## CITY PLANNING COMMISSION

- APPLICATION:**
- A. Special Permit to add drive-up window service to an existing 2,400+ sq. ft. 70 seat Dairy Queen restaurant on 0.33+ developed acres in the General Commercial (C-2) zone.
  - B. Lot line adjustment to merge 3 lots totaling 0.33+ acres in the C-2 zone.

**LOCATION:** 480 and 496 El Camino Avenue

APPLC. NO. P88-126 MEETING DATE May 12, 1988 ITEM NO. 16

# SITE PLAN

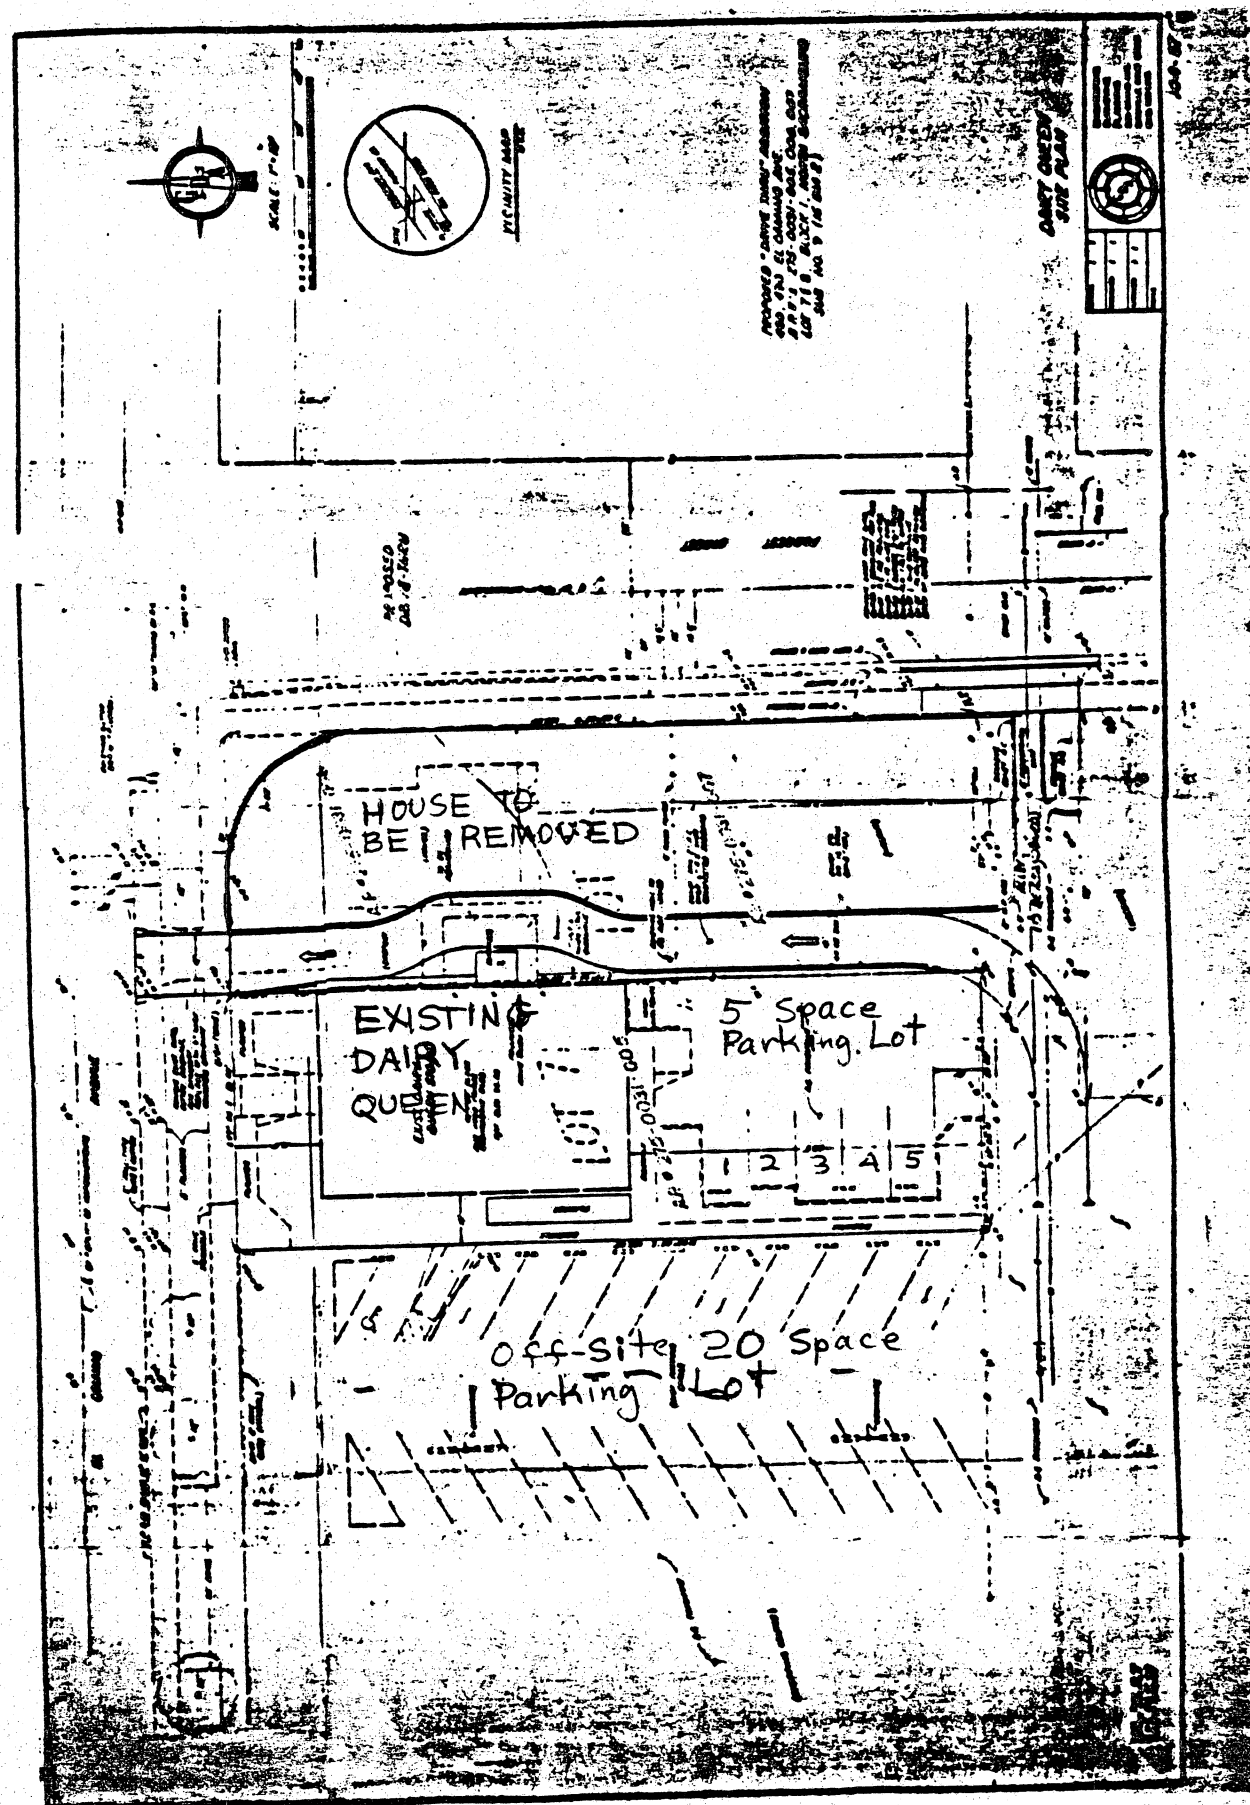
1. Drive-up aisle - Staff reviewed the site plan and notes that the proposed drive-up lane is proposed adjacent to the building except for a job at the drive-up window. The east elevation of the building is constructed of brown concrete block with no interest or variation. Staff discussed with the City Traffic Engineer the drive-up window jog and determined a five foot wide landscape planter adjacent to the east elevation would be more appropriate with the drive-up lane going straight. (Refer to staff modified site plan.) Staff recommends the drive-up lane be moved five feet to the east and a 5 foot wide landscape strip with tall, vertical shrubs be planted with living ground cover adjacent to the east elevation.

2. Fencing and Wall: Staff notes that approximately 30 feet of unimproved area lies between the drive-up lane and Forrest Street. City Code requires a wall where commercial uses abut residential zones or uses. During hearings in 1985 on the variance request for offsite parking, neighbors along Forrest Street expressed concern over the impact vehicles may have exiting Dairy Queen over the alley. Noise, exhaust and headlight glare were identified as intrusions into the residential area.

3. Drive up Lane Landscaping: With the proposed 15 foot landscape setback and wall adjacent to Forrest Street, a remaining 15 foot wide strip remains adjacent to the east side of the drive-up lane. Staff has reviewed this with the applicant and has determined lawn or ground cover with trees and shrubbery is appropriate. All landscaped areas are to be irrigated. With the landscaping and six foot wall along the Forrest Street frontage, staff has determined that an adequate buffer from the residential neighborhood is established.
4. Public Address System: The drive-up window requires a public address system and reader board. Neither are shown on the site plan. A revised site plan

shall show the location of the menu board and loudspeaker. The speaker shall be directed and adjusted in volume so that it will not be audible offsite.

7. Drive Up Lane: City Traffic Engineering notes that traffic on El Camino Avenue is heaviest during commute hours and that drive-up window customers may have difficulty exiting into the west bound traffic. Staff recommends that a right-turn only sign be installed at the exit so that cars can exit east bound and not obstruct traffic west bound on El Camino.

The stacking distance for automobiles is recommended at ten spaces as per the City Traffic Engineer. The revised site plan shall show a minimum of one car at the pick-up window, four between the pick-up window and reader board and speaker, one space at the reader board and four spaces behind the one at the reader board. The vehicle length used for calculations is 20 feet.

17. The drive-up lane shall be relocated five feet to the east to allow a five foot landscape planter adjacent to the east elevation. A mix of vertical and bushy shrubbery shall be planted adjacent to the wall. No jog in the drive-up aisle shall be allowed.

# STAFF MODIFIED SITE PLAN

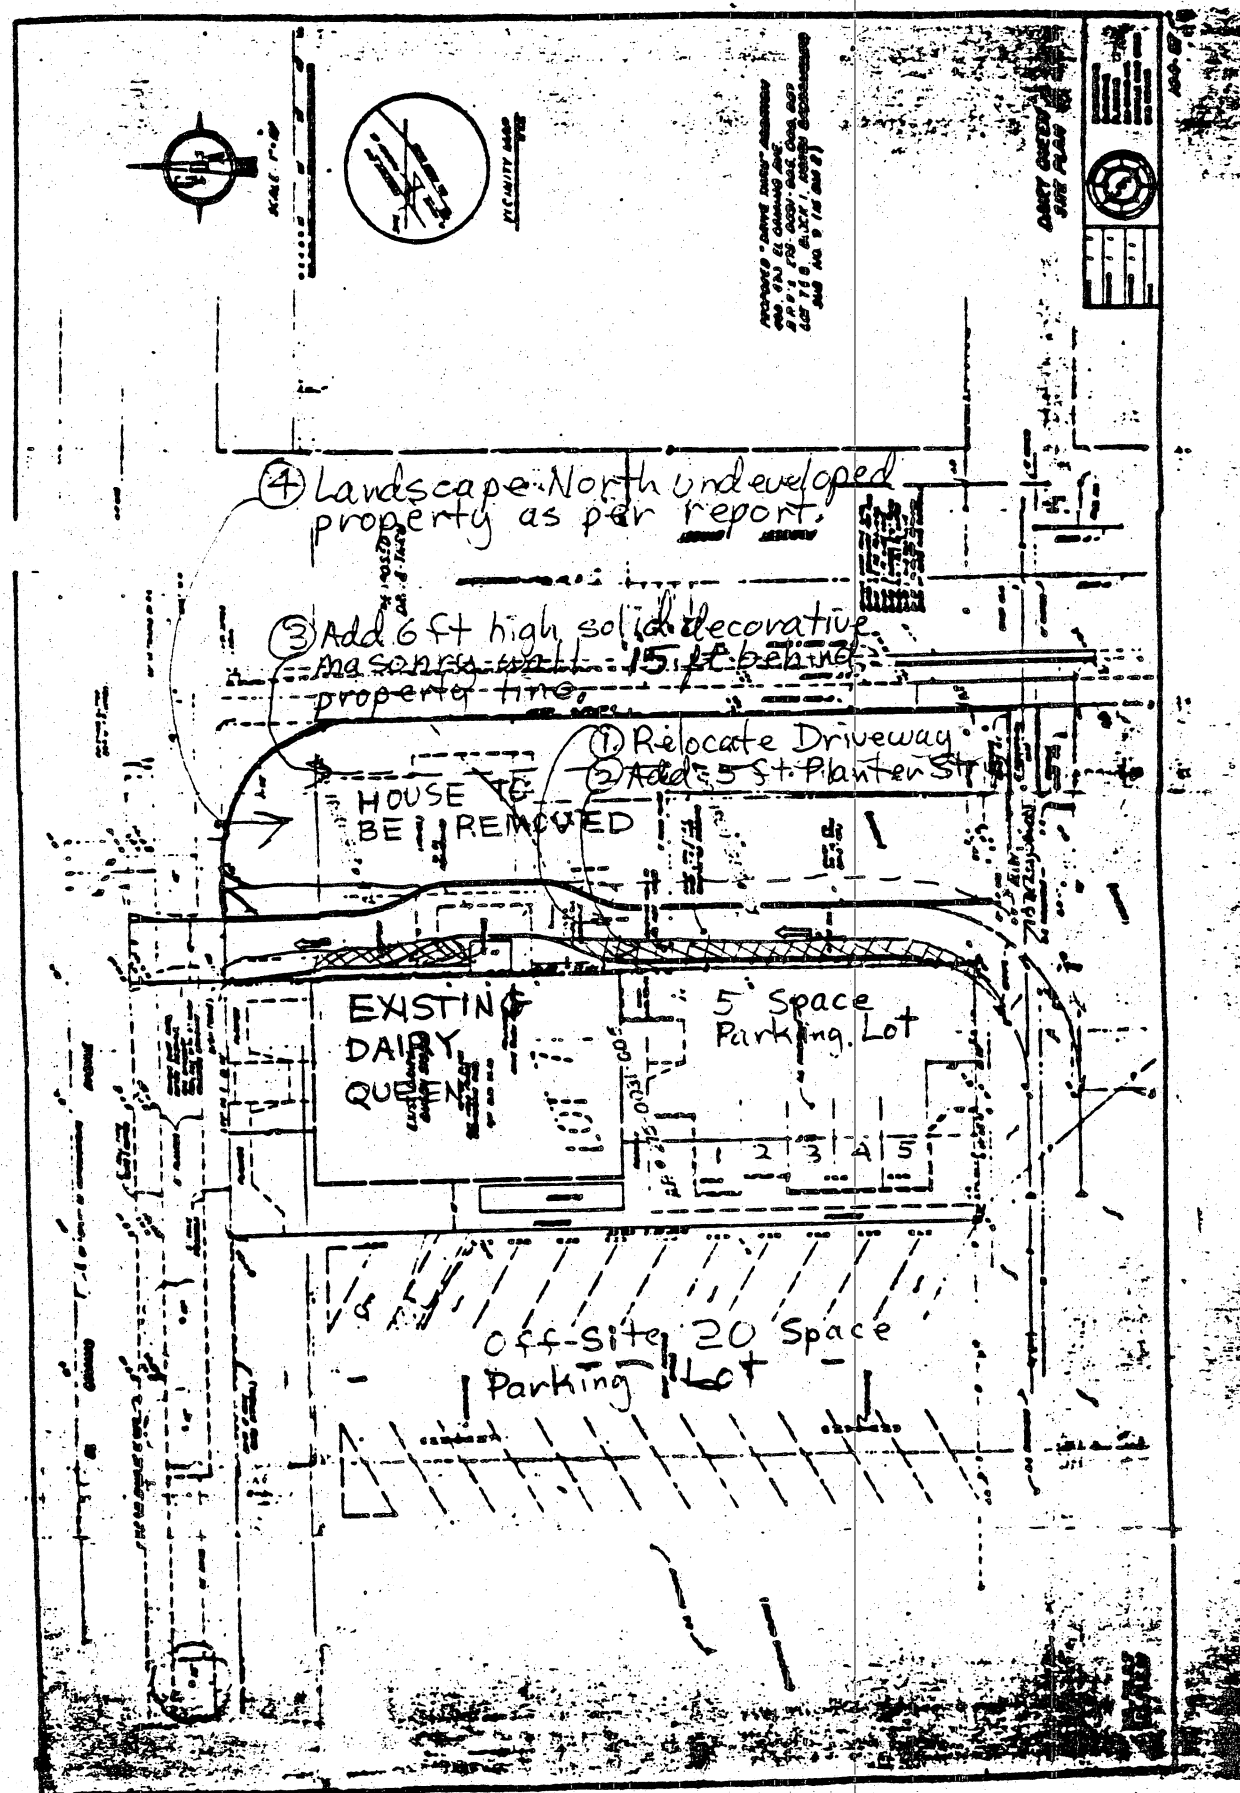
Staff has proposed that a 15 foot wide landscape buffer be installed the length of Forrest Street. In this landscape strip, a mix of five and 15 gallon evergreen trees on 20 foot centers is recommended. Living ground cover of lawn or ivy is recommended. No rock, gravel or bark mulch is to be used as ground cover. Behind the 15 ft. setback, staff recommends construction of a six foot high solid decorative masonry wall. The wall's height is to be reduced to three feet within the front yard setback of 16-1/2 feet from El Camino Avenue. Where the wall intersects the existing alley, either a pedestrian opening or gate is to be constructed which observes the underground utility easements. The wall shall extend westward along the south edge of the alley right-of-way the width of the Dairy Queen parcel. The wall will provide security and eliminate trespassing into neighboring yards.

2. A six-foot high decorative wall shall be shown on a revised site plan adjacent to Forrest Street compatible in color with the restaurant. The wall shall be setback 15 feet from Forrest Street and be reduced in height to 3 feet in the front yard setback area. The wall shall continue along the south edge of the alley the 100 ft. width of the merged lot.

18. Landscape plans shall show living ground cover over the entire area from Forrest Street to the drive-up aisle. In the 15 foot landscape area, a mix of 5 and 15 gallon evergreen trees on 20 foot staggered centers is required. Berming every two to three feet is also recommended.

ELEVATIONS

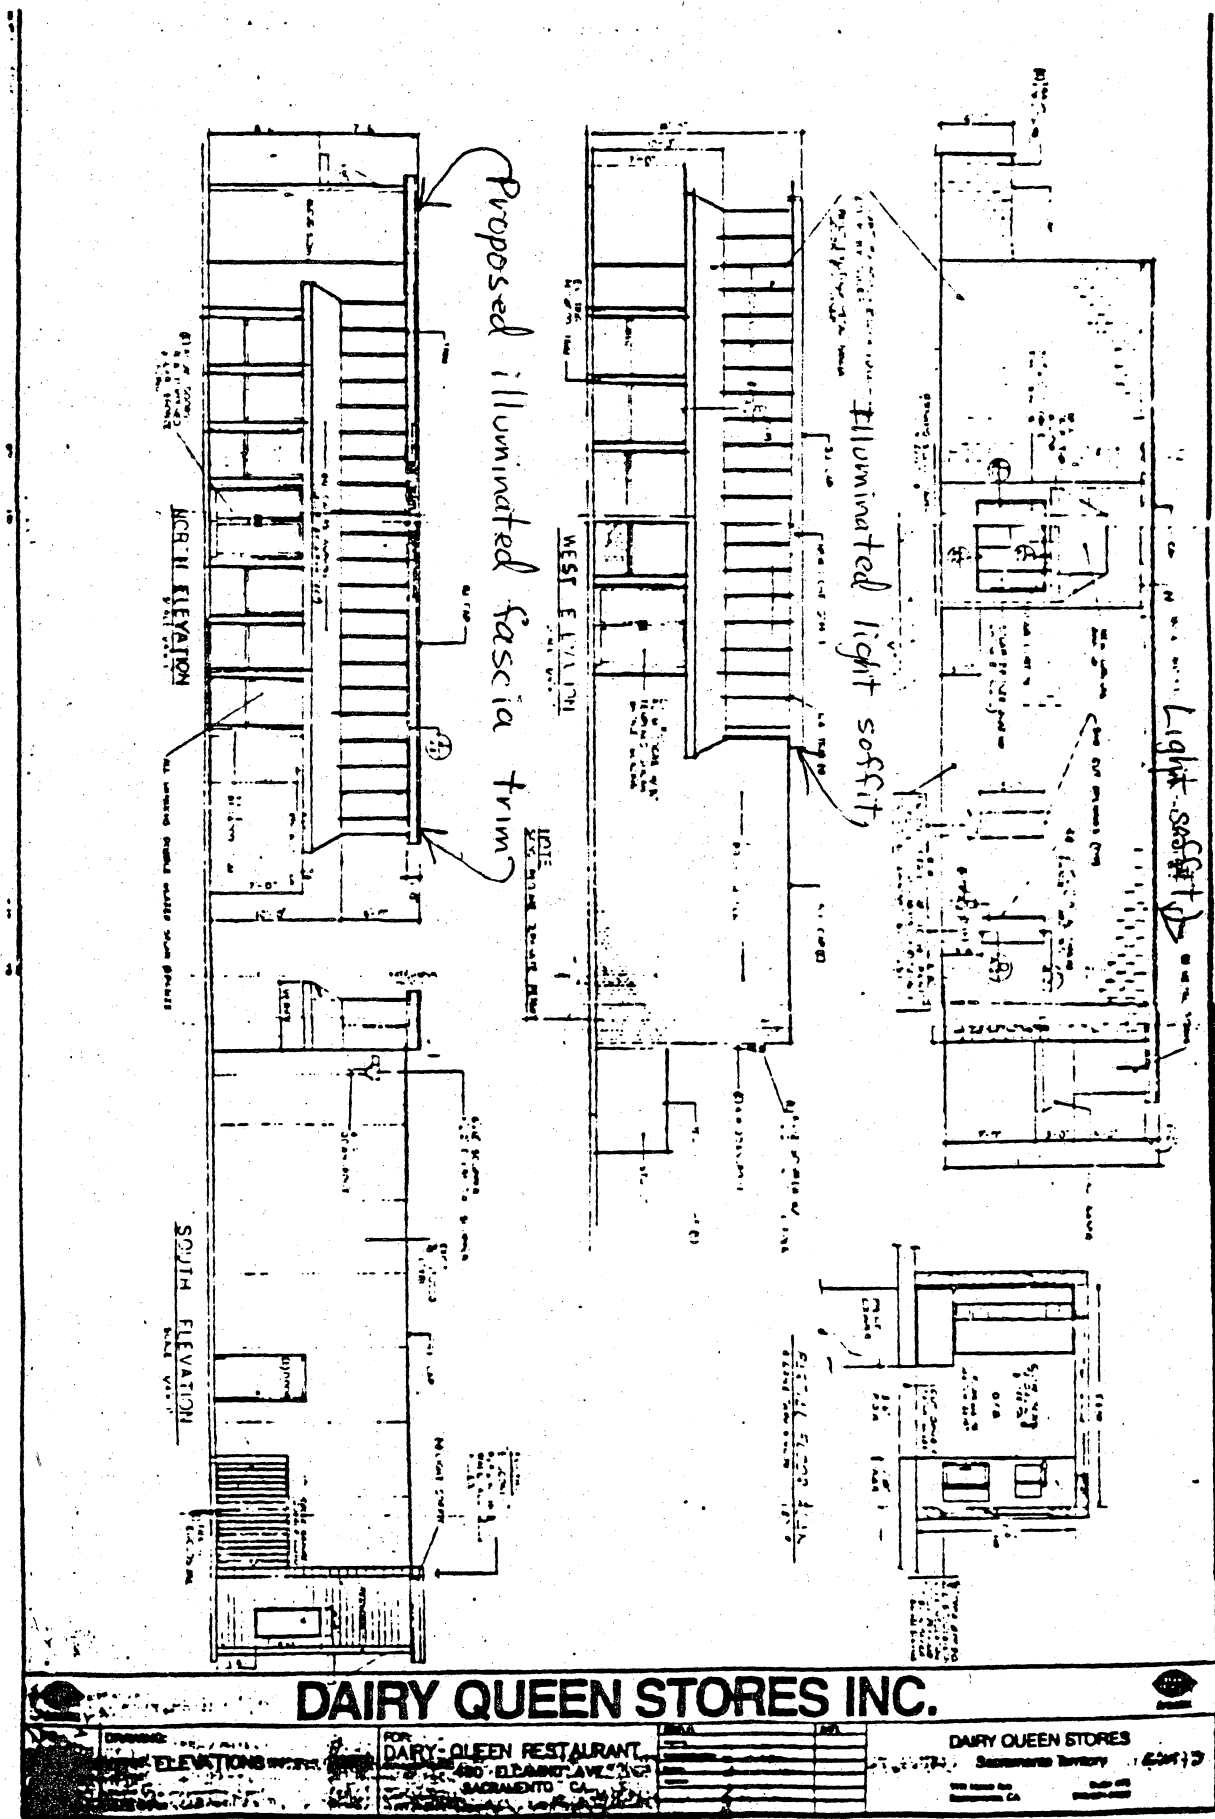
The applicant's elevations propose to modify the approved elevations in 1985. The addition of a canvas awning is proposed along the north and west elevations. Staff does not support locating an awning into the front building setback along El Camino Avenue. No color of the awning is proposed. Staff does not support the decorative awning since the building already projects close enough to property lines. No colors are indicated for either the awning or canopy. Staff does not support the structure or possible incompatible colors such as bright red or orange.

The applicant proposes an illuminated soffit along the top roof line on the east, north and west elevations. The soffit lighting outlines the building and is not allowed according to the City Sign Ordinance. Additionally, the lighting will reflect offsite onto residentially zoned or used property thereby creating a nuisance. Staff recommends the soffit lighting be eliminated from the elevations.

The east elevation proposes to have two saw cut windows and the drive-up window added. Otherwise, the wall remains stark and uninteresting. Staff has recommended a five foot wide landscape strip adjacent to the east elevation with shrubbery which will break up the lower portion of the wall. Staff recommends that a decorative trim element compatible with the north and west elevations be continued around to the east elevation along the top half of the wall area. This revised elevation shall be reviewed and approved by the City Design Review Coordinator prior to submittal for building permits.

19. The well shall be capped to City/County Health Department requirements.
20. Detailed elevations shall be revised to delete the canvas awning and soffit lighting. Elevations for the east view shall have a decorative trim element carried over from the west and north elevations. Elevation revisions are to be reviewed by Planning Director and approved prior to issuance of building permits.
